WEST ELBOW COMMUNITIES

Local Area Planning Project

Phase 3: REFINE - What We Heard Report
Winter 2025

Map 1: 17 Avenue SW (west of 14 Street SW)

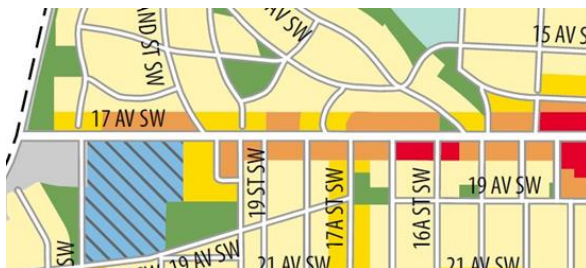
- Scale on 17th Avenue should be 4-storeys all along Scarboro neighbourhood.
- Pragmatic. Decidedly fine - closer to goals on main streets. Let it evolve organically - delaying for a main streets master plan is not ideal. Main Streets is woefully delayed and underfunded.
- Agreed that the area between Scotland and Summit should be 4 storeys (low-modified)
- Suggesting to make it neighbourhood connector across 17th Avenue giving onto Scarboro; it's a small historic neighbourhood (330 homes), keeping the residential character is important
- Mainstreet needs a concept and vision for the area west of 14th St. Until then, we should limit height and scale, especially on the north side due to impacts involving height etc.
- Neighbourhood connector less intensive is better. Quite a slope so not a lot of potential to be too intense.

- Instead of downscaling the building scale in the blue box, could potentially look at expanding the previous scale further north. Or perhaps look at increasing building scale elsewhere to replace the higher density housing lost from this change

- Change to building scale does make sense. It's good to have a buffer between lower and taller buildings
- Building Scale: Changing the laneless portion along 17 AV SW to a lower scale makes sense given the conditions.

- Urban Form: The remaining portion of 17 AV SW could be adjusted so there is a more consistent Urban Form (suggest Neighbourhood Flex to provide maximum flexibility) throughout.

Map 2: 14 Street SW (26 Avenue SW and Premier Way SW)

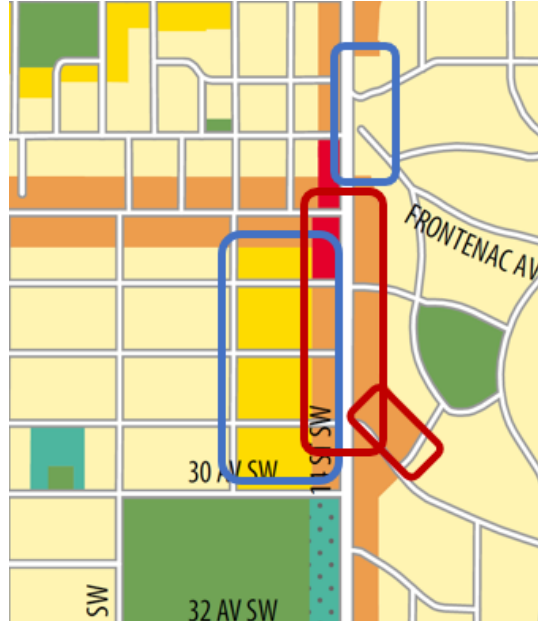
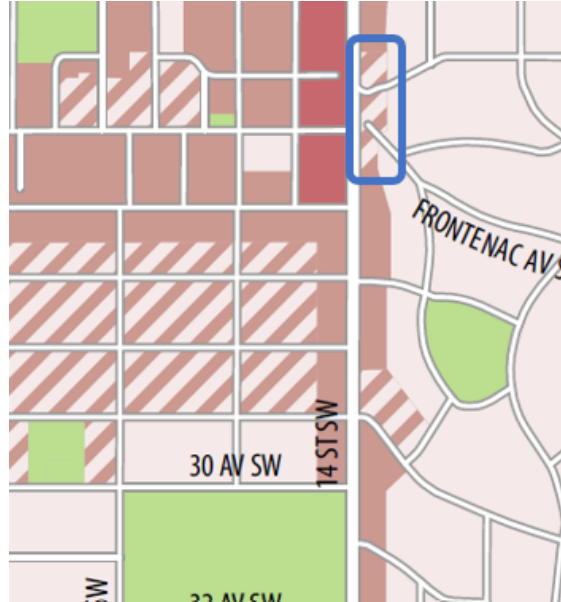
- Around the intersection of 16th and 30th avenue - could change in the future and might be potential to be commercial. Extend connector down 30th Because of C space and south calgary park

- I like this change, to support building more of a node around 14 St and 26 Av
- CHAT- These changes make sense here
- I'm a fan of Neighbourhood Flex (in certain areas where commercial may take time to establish) to provide greater flexibility and room for growth / change going forward. For

example, commercial at-grade may not always succeed and result in a dead at-grade experience, so having the option to provide residential at-grade is nice and may result in a livelier streetscape.

- Change to building scale map makes sense.
- On the urban form map, some Neighbourhood Connect around the C-Space as seen in the older version makes sense to me.

Map 3: 14 Street SW and Council Way SW (32 to 38 Avenue SW)

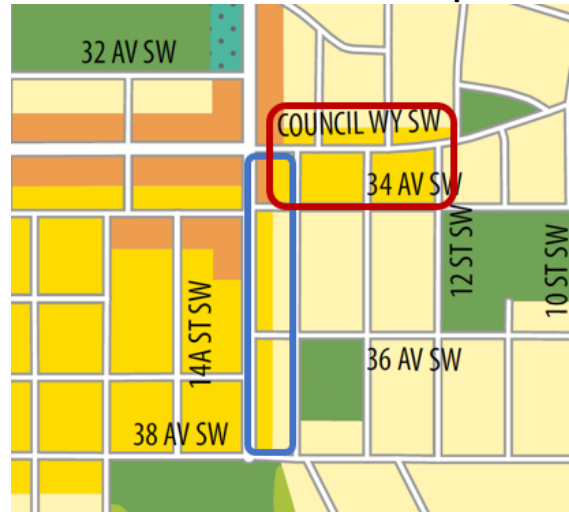
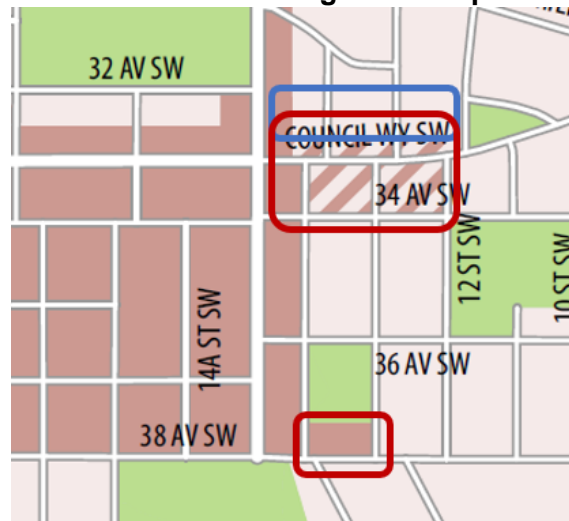
- Revised Urban Form map makes sense along Council Way — this change will provide greater flexibility on these parcels. It also provides greater clarity to the intent of fronting along 14 ST by adjusting it to one side of the block.

- The parcel considered for up to 6 storeys at the intersection of 14 ST and 38 AV SW seems appropriate for this scale. This road and intersection is busier and the parcel is directly across from a major amenity (River Park and Sandy Beach Park).

- The 6th story parcel on 38th seems appropriate.
- The intersection (14th st and 38th) may need revising with higher density in the long term. I think it may be a combination of things – traffic control or lights there in the future. Higher density – apartment blocks in some of the empty lots there. Better lit pedestrian walkways or ways to see the cars.

Map 4: North Glenmore Park

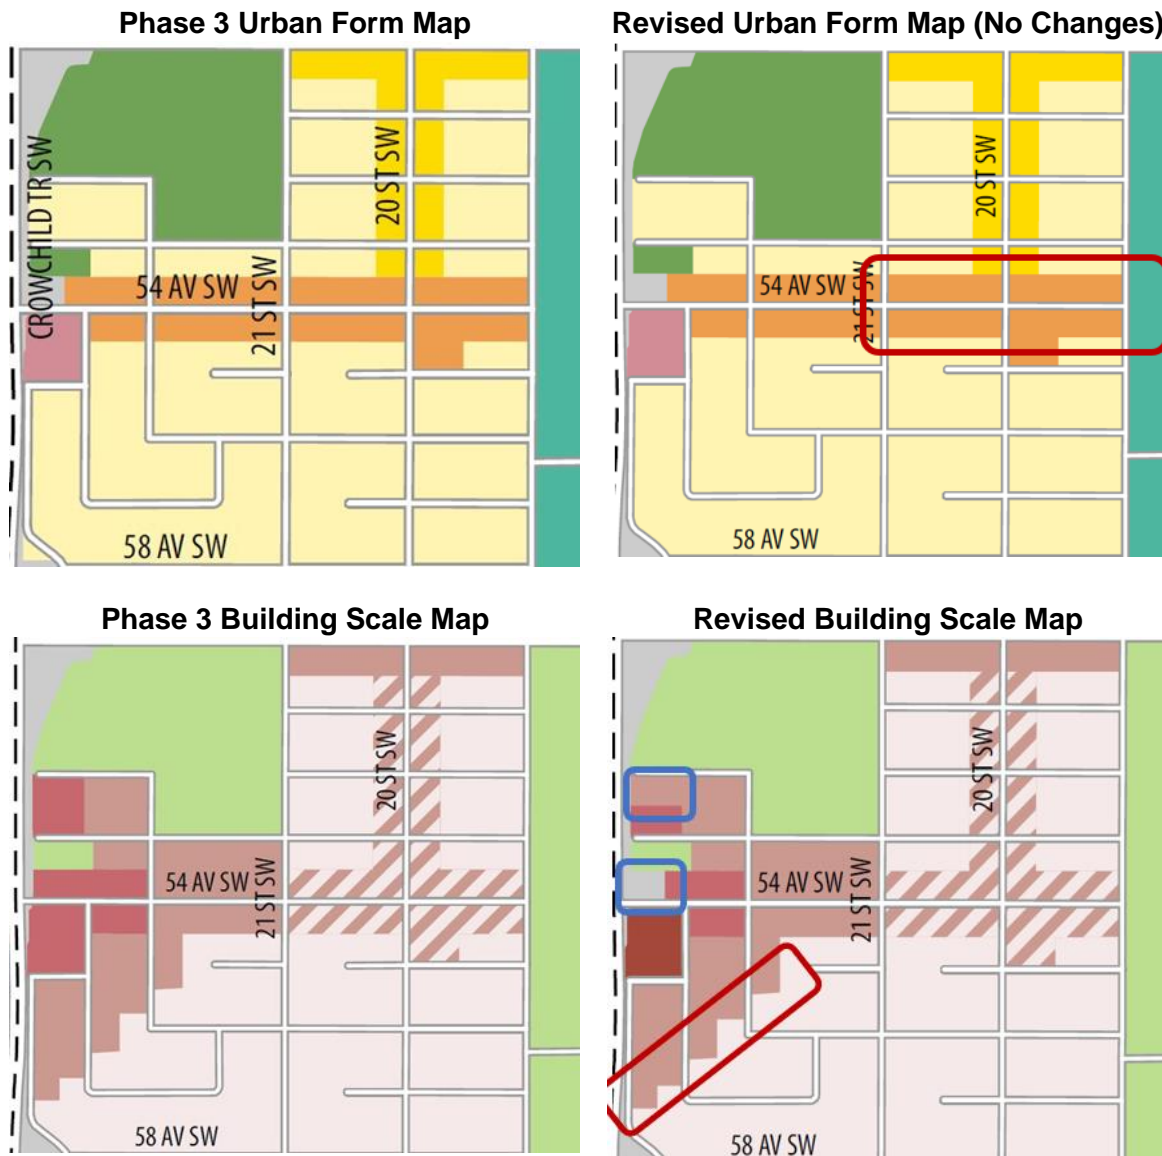
- I want to add a comment regarding my North Glenmore (north half) community. In particular, the jigsaw pattern created around the 54th Avenue and Crowchild Trail Transit-Max (BRT) station. It seems naive and overly simplistic to impose this radius pattern "transition zone" on the area surrounding the existing commercial plaza.
- Keep as neighbourhood flex, good spacing for a commercial corridor from 33/34
- Keep flex - will take time for this area to redevelop so avoid trying to make winners and loser blocks.
- 12 story building close to Glenmore park too high

- Comment: One area that could be substantially different in the future. Potentially missing out on existing business
- How far should we go into North Glenmore Park? What is the concern with the higher density there? It was primarily shadowing. Support for 6 stories, 4 then transitioning into 3.

- Shadowing would be mostly evening in the high summer with sun in the NW
- For the horizontal red box on the building scale map. If this needs to be a scaled transition, keep it as is, but add 3-4 storeys south of it as that transition.

- I would keep the neighbourhood flex and also the 6 stories, but then you could add a 4-story transition beyond it. It's close to the university so apartments for students could go here.

- CHAT - For this area around 54th Ave, I think it's very good to lower the max tower height where shadowing could impact green space and other lower height buildings

- In favour of the two blue circles here - 6 or 4 storeys here – makes more sense to transition- step down to 4 and more typical homes better than have an abrupt transition where possible

Map 5: 19/20 Avenue SW (Richmond Rd SW)

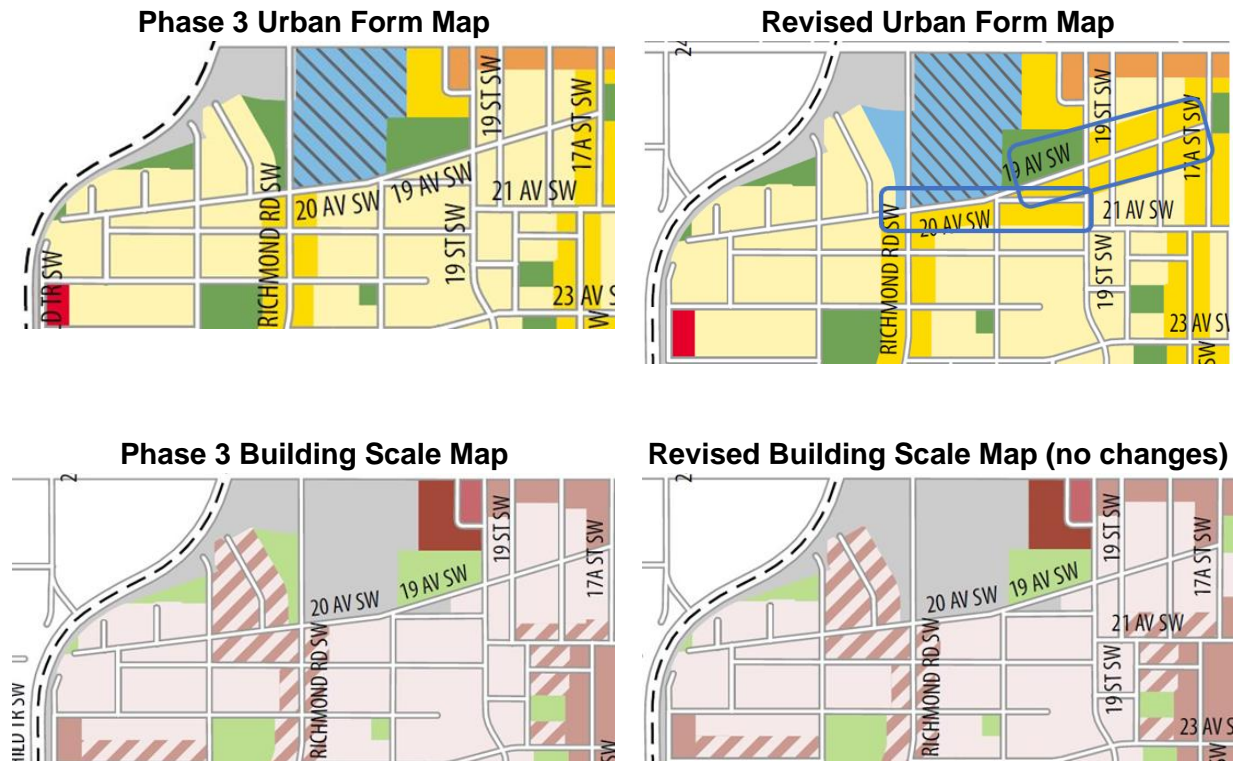
- Question: I heard that 20th St is going to be "punched through" (due north) to 17th - true? If so, does it make sense to allow for more commercial to the east?

- 19th ave is an odd street and the neighbourhood connector while in theory makes sense to connect Richmond road and 17a, but until there is a plan to change/develop the medical centre I'm not sure what benefit would come from the change.

- I think commercial should be allowed in the blue boxes. Those properties won't be forced to change to commercial, why not give them the option? Agreed!
